Subject Facility: **North Country Environmental Services, Inc., 581 Trudeau Rd, Bethlehem**
Permit No DES-SW-SP-03-002
Solid Waste Facility Inspection Report

On September 9, 2025, the New Hampshire Department of Environmental Services conducted a focused landfill cover inspection at the subject solid waste facility. The inspection was conducted to determine compliance with landfill cover requirements in RSA 149-M, the New Hampshire Solid Waste Rules Env-Sw 100-2000, and the facility permit.

IMG_1662

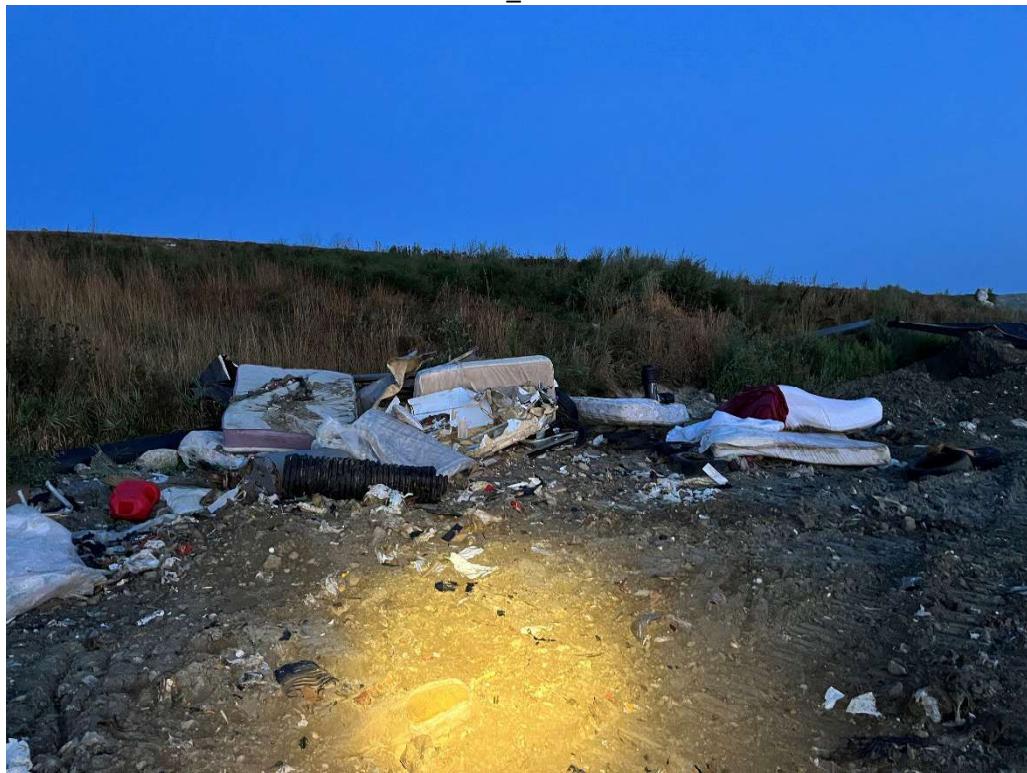
Env-Sw 806.03(c): At landfills receiving municipal solid waste, Env-Sw 806.03(c) requires cover material to be placed over all exposed waste no less frequently than at the end of each operating day. During the inspection, incomplete cover application was observed at the working face (IMG_1662, IMG_1663, IMG_1666, IMG_1667).

Corrective Action: Immediately place adequate cover material over all waste at the facility and submit photos to NHDES showing cover application. Note: On September 9, 2025, the facility submitted photos to NHDES showing appropriate cover application in the areas noted in this report.
